**BAGHDAD POLICE COLLEGE  
BAGHDAD, IRAQ**

**SIGIR PA-06-078.2**

SUBJECT: Report on Project Assessments of Reconstruction Work Performed Under Task Orders 06 and 29 at the Baghdad Police College, Baghdad, Iraq (Report Numbers SIGIR PA-06-078.2 and PA-06-079.2)

## Baghdad Police College, Baghdad, Iraq

Figure 1. Contractor design for installation of hot and cold water lines for cadet barracks showers

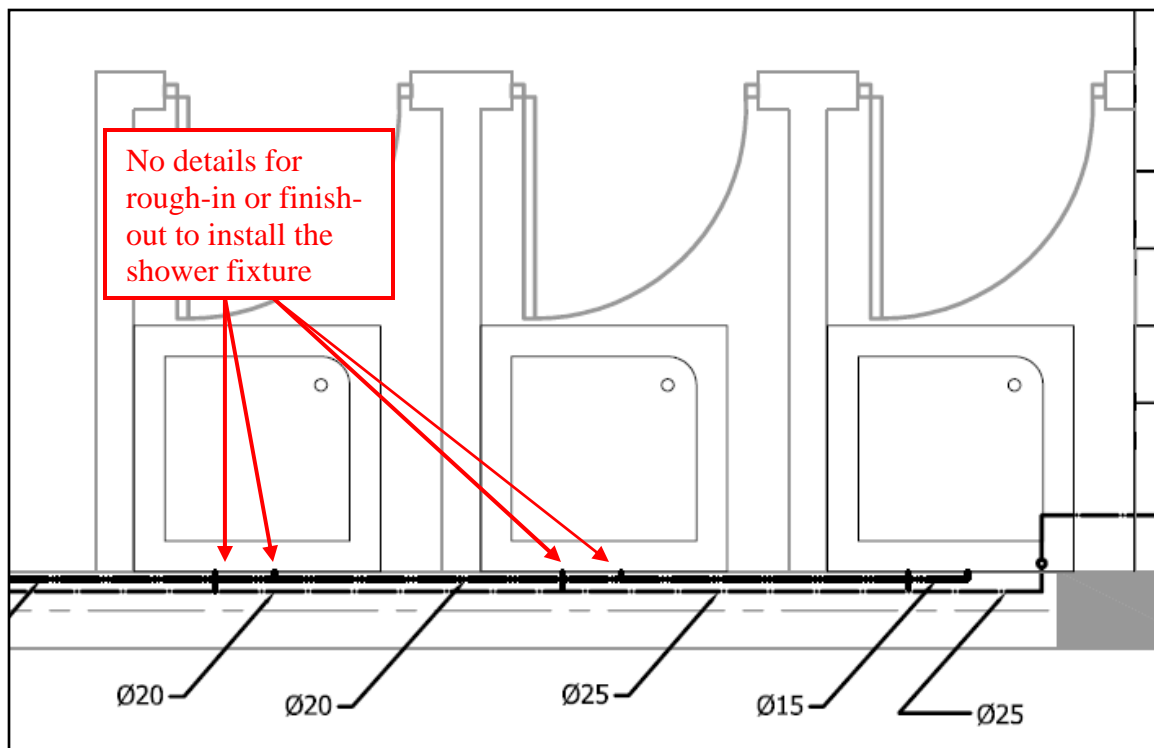
Detailed design drawings for the rough-in and finish-out of the plumbing fixtures were not provided by the contractor. Instead the drawings were generic and did not specify the distance that the hot and cold water lines should extend beyond the wall (i.e. rough-in) for the plumber to connect to the shower faucet and head (Figure 1). In addition, the drawings do not provide an enlargement of one shower as an example to provide specific installation details, such as the type of plumbing fixtures to use (i.e. finish-out). Without detailed design drawings, the subcontractor does not have adequate guidance to properly install the water lines and plumbing fixtures.

Figure 2. Floor plan and soil pipe detail for a typical cadet barracks facility

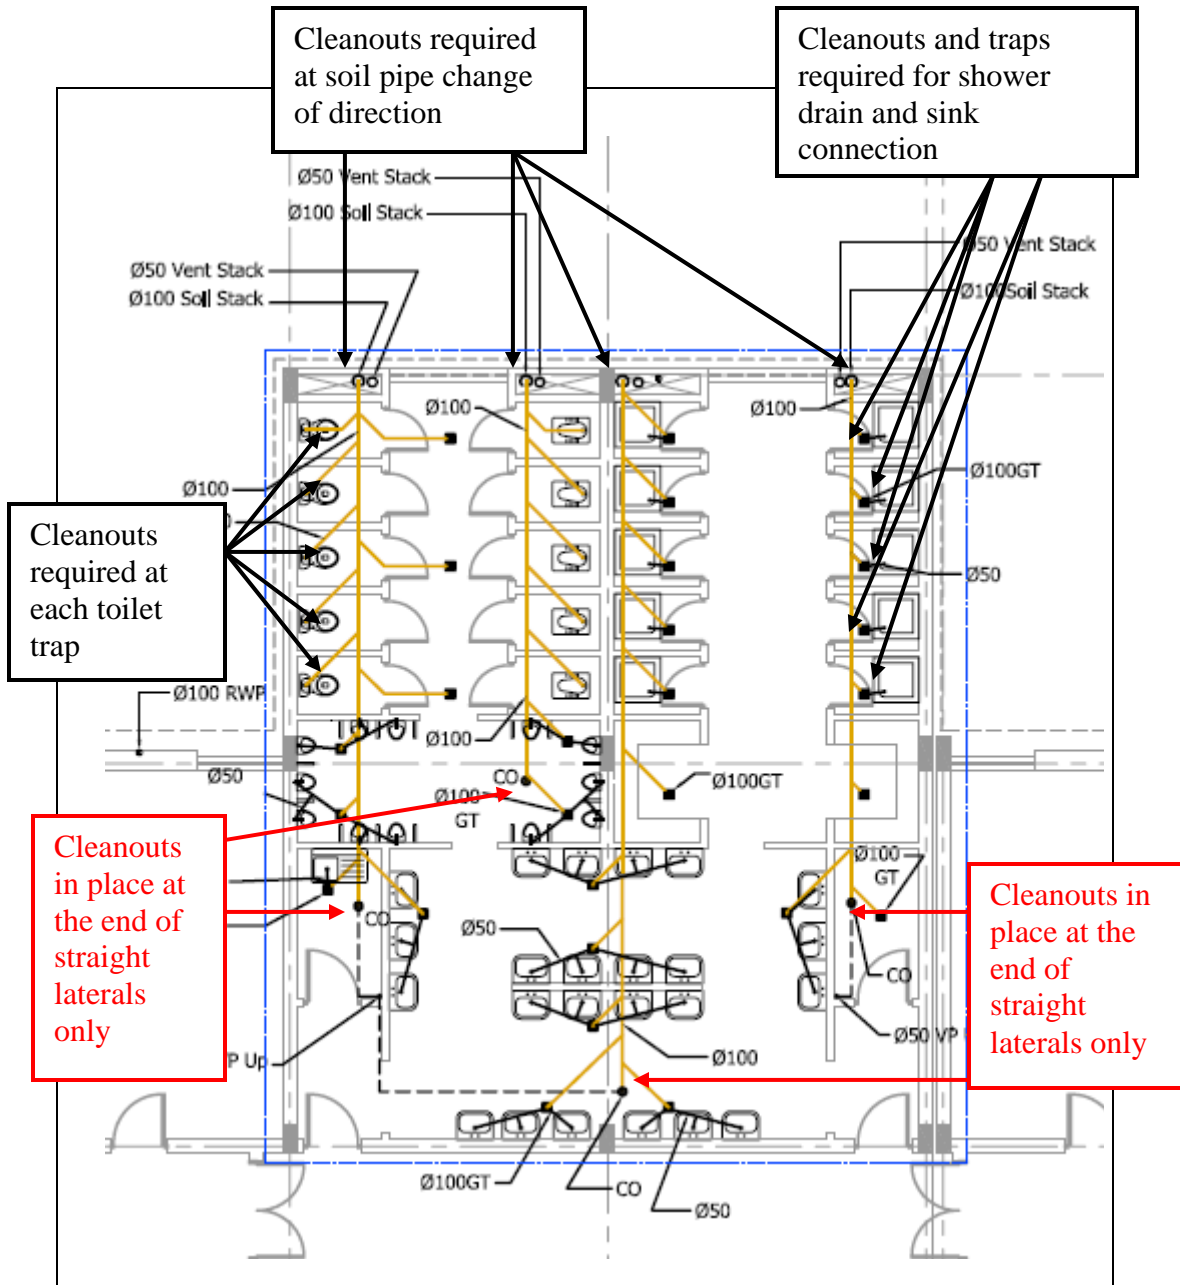
The as-built drawings for the cadet barracks indicate cleanouts were only used at the far end of a straight run of soil pipe, not for every toilet trap and change of direction (Figure 2). The government engineers reviewing the cadet barracks design drawings failed to detect and identify the lack of a sufficient number of cleanouts and traps at the correct locations. As a result, not only did the contractor not follow the specific code requirement, which is compounded by the contractor's poor plumbing installation and construction, but the likelihood of the sewer lines backing up increased significantly, even under normal use.

In addition, on the as-built drawings for the "typical floor drainage" cadet barracks design, the listed design references were the Practical Plumbing Design Guide, National Plumbing Code, and Plumbing Engineering Services Design Guide – The Institute of Plumbing; however; there is no reference to the standards required by the TO – the IPC. Compliance with IPC criteria for design, construction, and installation was required by the TO.

Figure 3. Contractor's 60% design drawings with vague reference to expansion joint

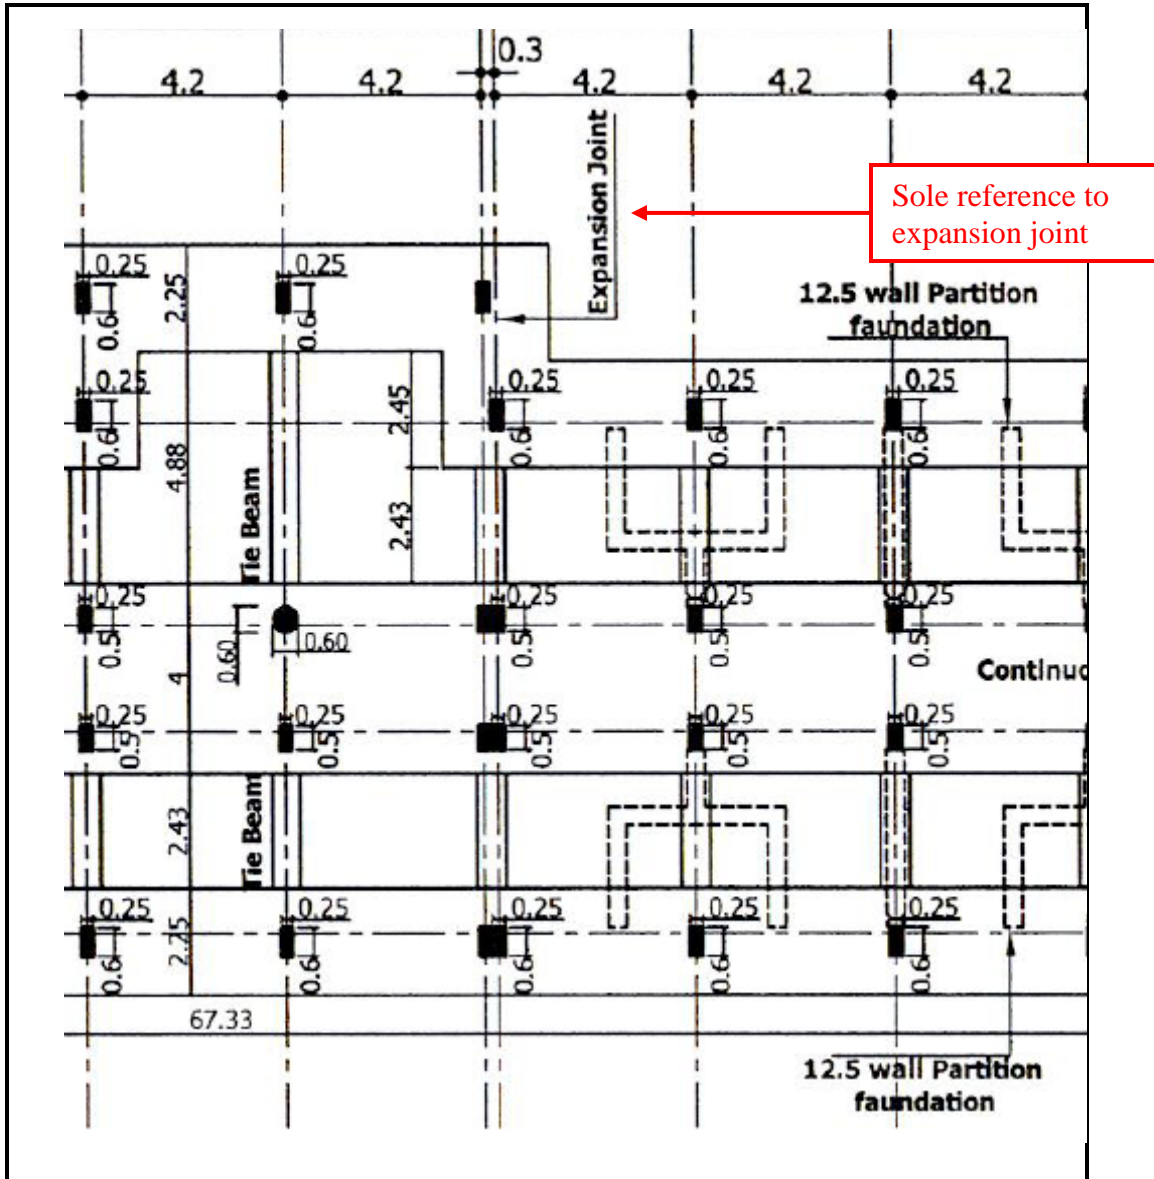
The 60% design drawings for the instructors' barracks did not include any specific details for the use and installation of expansion joints; instead there are only vague references to the expansion joints in the design drawings (Figure 3). The government engineer's design reviews did not identify the obvious absence of this item on the design drawings and subsequently did not require the contractor to resubmit the drawings with exact expansion joint details. Specific expansion joint details are critical, since properly designed and correctly installed joint systems are capable of protecting buildings and structures from damage caused by thermal expansion and contraction as well as anticipated foundation movements.

Figure 4. Contractor's as-built drawing for floor expansion joint

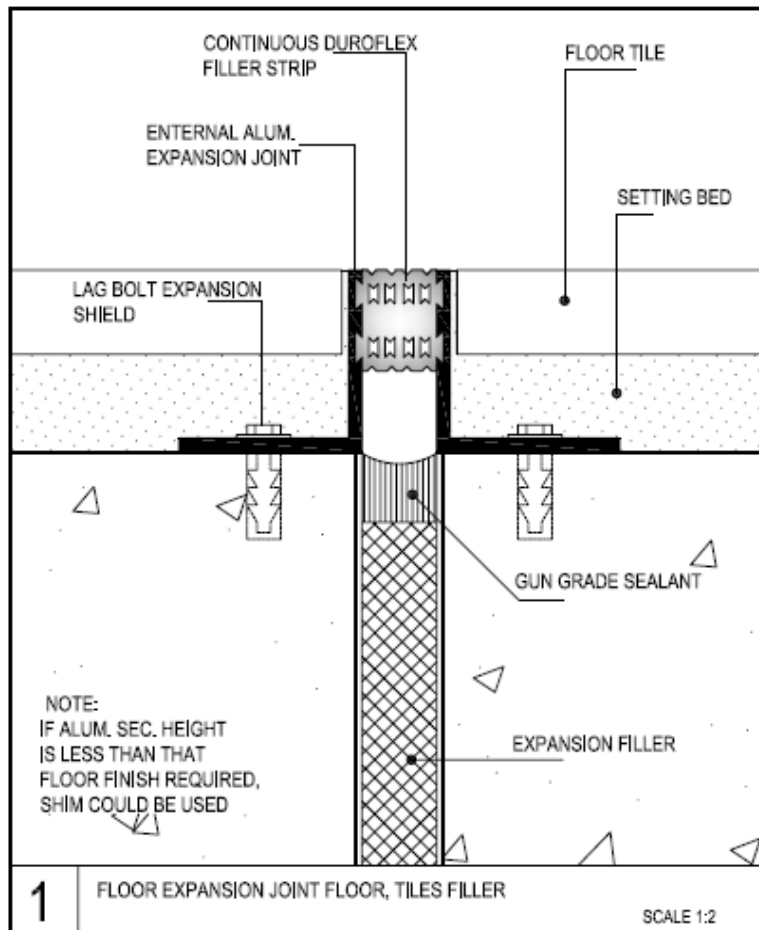
More importantly, we discovered significant expansion cracks on the exterior and interior of the buildings (Site Photos 17-20). We determined that the contractor's as-built drawings (Figure 4) do not reflect the reality of what was actually constructed at the instructors' barracks.

Figure 5. Contractor's as-built drawing

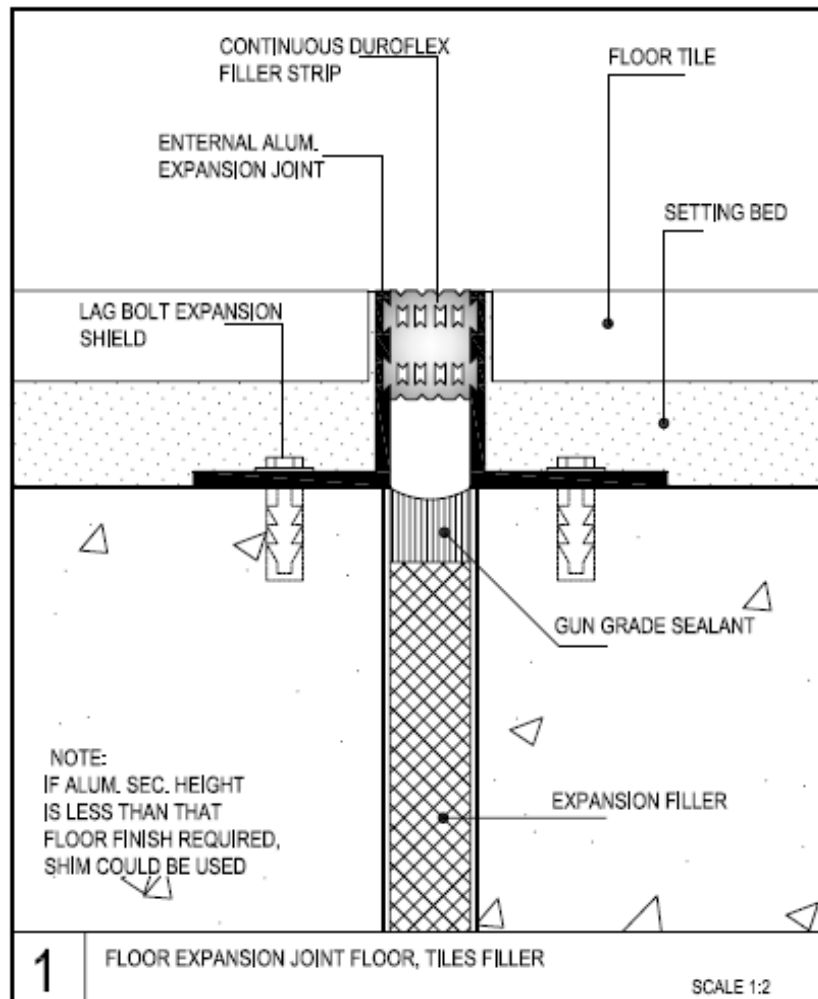
For instance, for the instructors’ barracks, we identified significant expansion cracks on the interior, exterior, and roof of the buildings (Site Photos 65-68). Parsons’ as-built drawings claim to have constructed a specific type of expansion joint system for floor, interior wall, ceiling, exterior wall, and roof (Figures 5 and 6). The as-built drawings submitted show a very specific prefabricated engineered joint system. We found little or no evidence of designed joint systems in place to protect the building from vertical and horizontal movement. When comparing the building’s construction and damage to the as-built drawings submitted by Parsons, it is apparent that the as-built drawings do not reflect the actual construction done.

**Figure 8. Contractor's as-built drawing for ablation unit, which indicates connection to main water and sewage networks.**

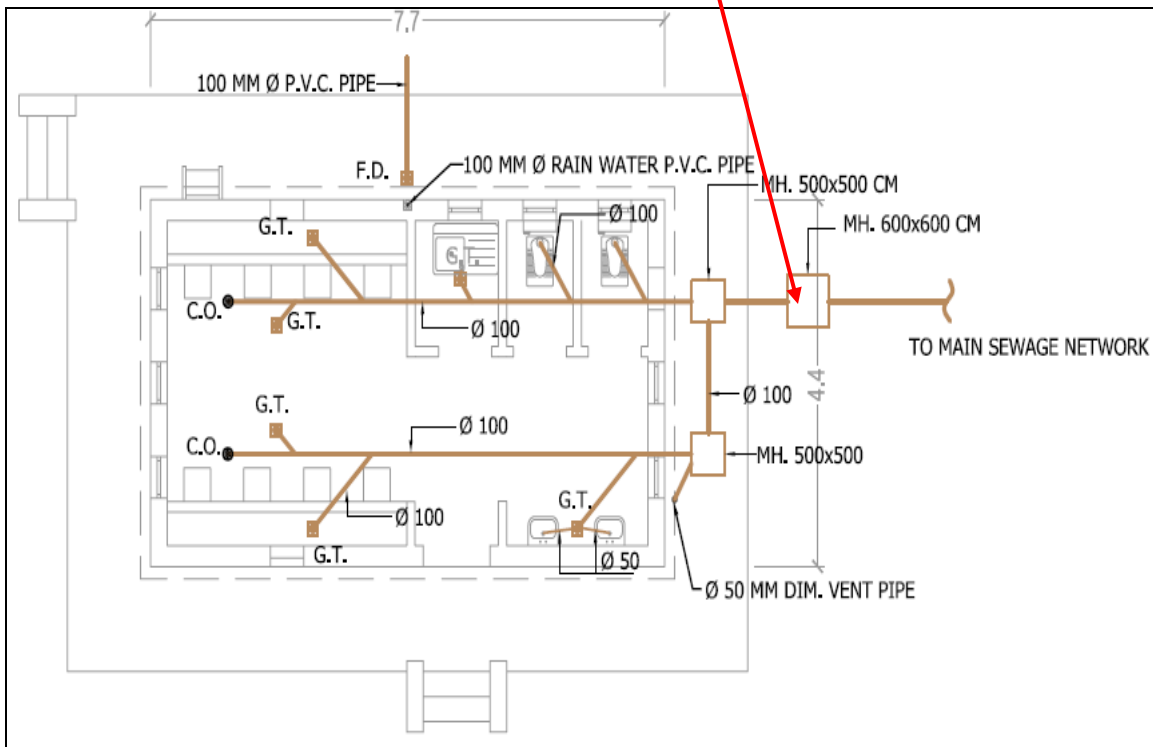
Finally, for the ablation unit, the as-built drawings submitted by the contractor indicate the facility is connected to the main water and sewage networks (Figure 8); however, during our initial site visit, we verified the facility was not connected to either the main water or sewage networks (Site Photo 71). The connection to the main water and sewage networks was not completed until late November 2006 and was completed by another contractor.

**Figure 9. Contractor's as-built drawing**

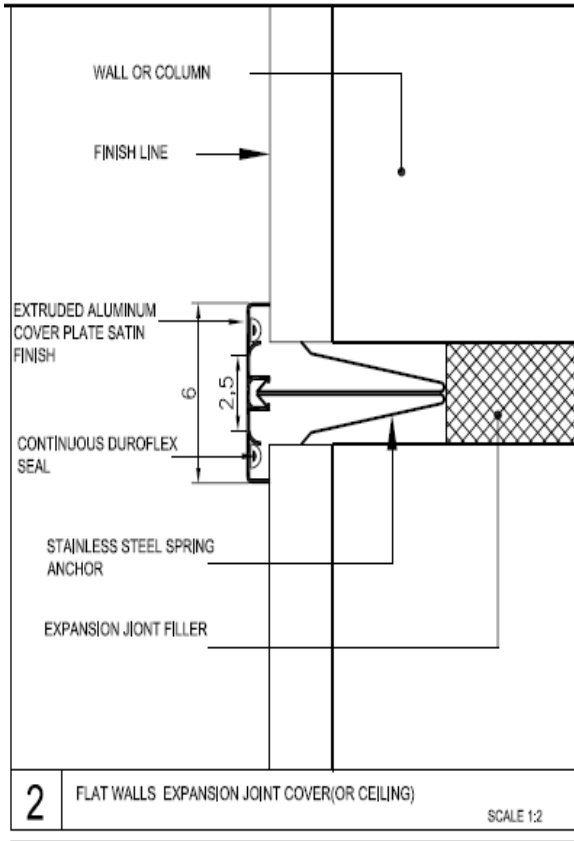
The contractor's as-built drawings, in our opinion and in GRD's own assessment, are not complete and accurate. For example, the as-built drawings for the instructors' barracks buildings show a very specific prefabricated joint system (Figure 9). We found little or no evidence of designed joints in place to protect the building from vertical and horizontal movement. Not only did the instructors' barracks suffer from significant interior and exterior expansion cracks (Site Photos 82 and 83) and runs the risk of reducing the buildings' life expectancy, equally troubling is the fact the GRD does not know if the contractor was paid for installing the prefabricated joint system claimed in the as-built drawings. The government already paid Parsons for inaccurate as-built drawings (since the as-built drawings reference prefabricated expansion joints which are not present on the buildings) and quite possibly paid Parsons for the installation of the prefabricated joint system.

Figure 10. Contractor design for installation of hot and cold water lines for cadet barracks showers

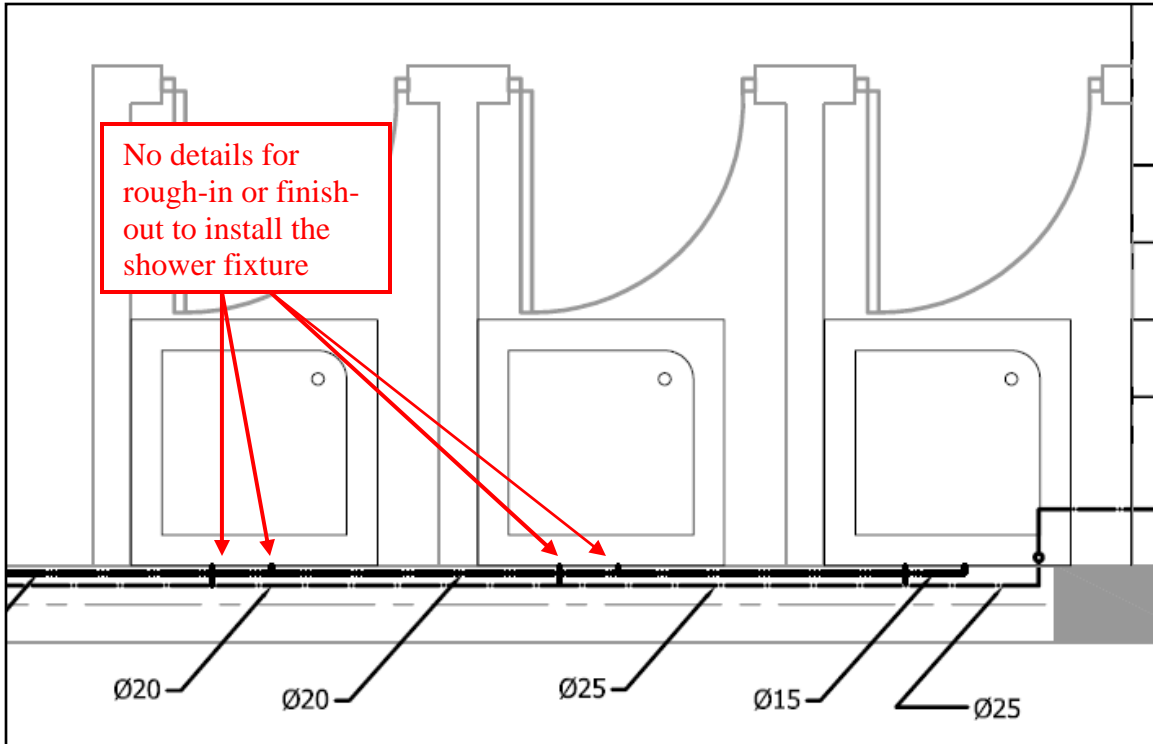
Detailed design drawings for the rough-in and finish-out of the plumbing fixtures were not provided by the contractor. Instead the drawings were generic and did not specify the distance that the hot and cold water lines should extend beyond the wall (i.e. rough-in) for the plumber to connect to the shower faucet and head (Figure 10). In addition, the drawings do not provide an enlargement of one shower as an example to provide specific installation details, such as the type of plumbing fixtures to use (i.e. finish-out). Without detailed design drawings, the subcontractor does not have adequate guidance to properly install the water lines and plumbing fixtures.

**Figure 11. As-built drawing for expansion joint**

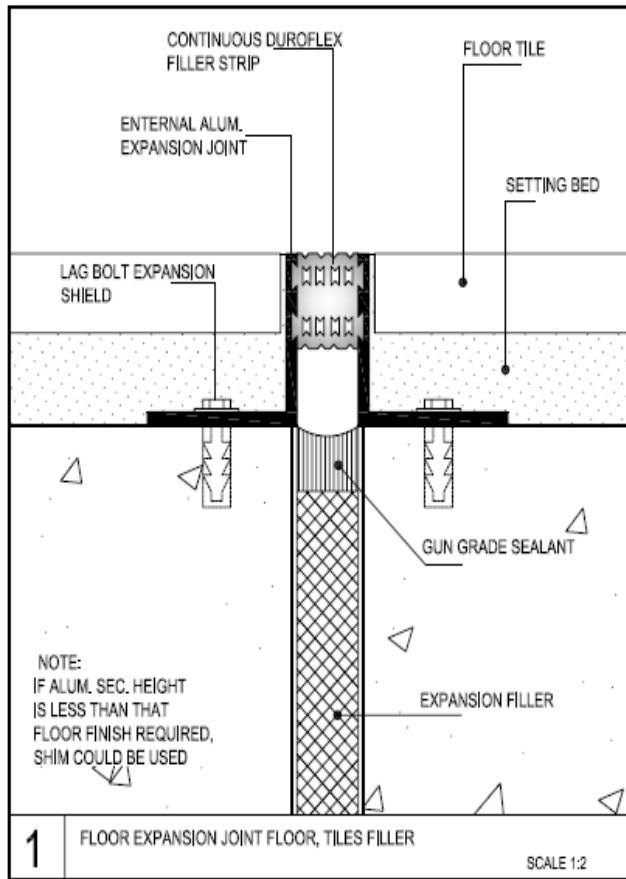
We found little or no evidence of designed joints in place to protect the building from vertical and horizontal movement. Properly designed and correctly installed joint systems are capable of protecting buildings and structures from damage caused by thermal expansion and contraction as well as anticipated foundation movements. The damage we identified is a direct result of not properly installing the expansion joints according to the as-built drawings (Figures 11 and 12 and Site Photos 132-135). The absence of properly installed expansion joints could potentially result in further damage to the buildings' interior and exterior, as well as, significantly reduce the buildings' life expectancy.

**Figure 13. As-built drawing for expansion joint**

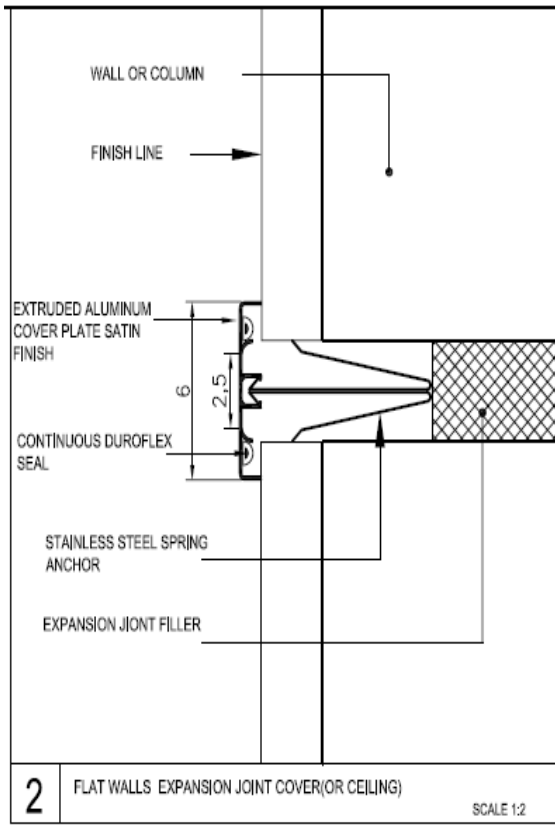
We found little or no evidence of designed joints in place to protect the building from vertical and horizontal movement. Properly designed and correctly installed joint systems are capable of protecting buildings and structures from damage caused by thermal expansion and contraction as well as anticipated foundation movements. The damage we identified is a direct result of not installing the expansion joints according to the design drawings (Figure 13 and Site Photos 138 and 139). The lack of properly installed expansion joints could potentially result in further damage to the buildings' interior and exterior, as well as, significantly reduce the buildings' life expectancy.
